HISTORIC AND DESIGN REVIEW COMMISSION

HDRC CASE NO: 2017-181
ADDRESS: 330 E MYRTLE
LEGAL DESCRIPTION: NCB 1751 BLK 6 LOT 2 & W 2.8 OF 1
ZONING: MF-33 H
CITY COUNCIL DIST.: 1
DISTRICT: Tobin Hill Historic District
APPLICANT: Ricardo McCullough/McCullough Design Associates
OWNER: Imagine Holdings
TYPE OF WORK: Construction of a two story addition, modification of existing facade elements, roof replacement, chimney removal

REQUEST:

RIGHT ELEVATION
SCALE 3/16" = 1'-0"

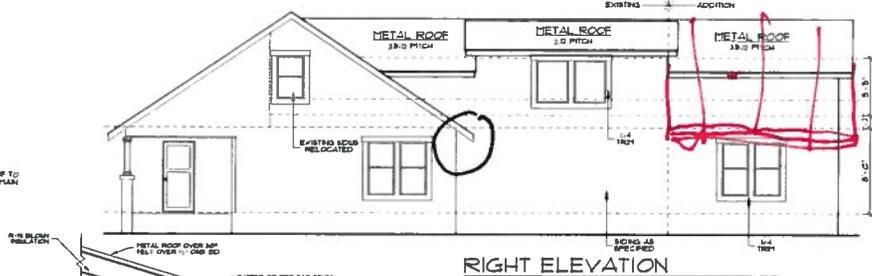
- f. ROOF DESIGN - The proposed addition's roof will match the height of the existing ridgeline and extend into the rear of the lot. Currently, the lot on the east side of the house is vacant, and its east façade is directly visible from the public right-of-way. The proposed roof features details that break the plane of a continuous roof form, including side dormers with simple shed roofs reflective of the existing structure's primary roof configuration, and a steeper roof pitch with extended rafters at the rear 1/3 of the addition that directly echoes the existing roof form to be removed to make way for the addition. The extension reflects the historic roof pitch while adding dimension and depth to the side elevations as to not overwhelm the primary structure on the east façade. Staff does find the roof form compatible with the existing structure in its architectural gestures and consistent with the guidelines.

1. Staff recommends approval of the two story addition based on findings a through h with the following stipulations:
 - i. That the applicant submits a set of elevation drawings indicating the final roof form for staff approval.

PROPOSED ROOF PLAN
SCALE 1/8" = 1'-0"

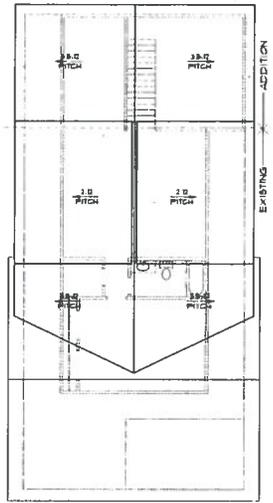
Modify roofline in rear to match former roofline. Kent:
"backend". Both ok with that gesture, interior is just
open space. Need window details, show where they will
be removed, replaced, and where new ones will be.

LEFT ELEVATION
SCALE 3/16" = 1'-0"

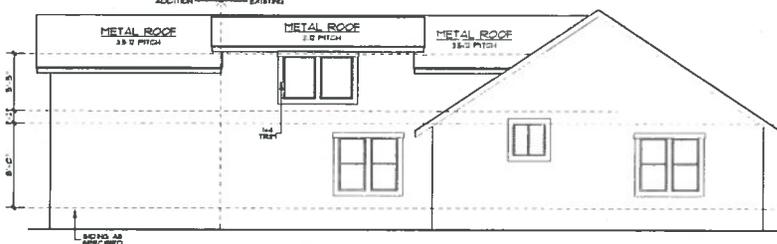
window change on left facade

how new side windows align - adjust shower
layout

- ii. That the applicant submits a window schedule indicating where existing windows will be removed, where existing windows will be relocated, and where new windows will be installed in both the existing structure and new addition.
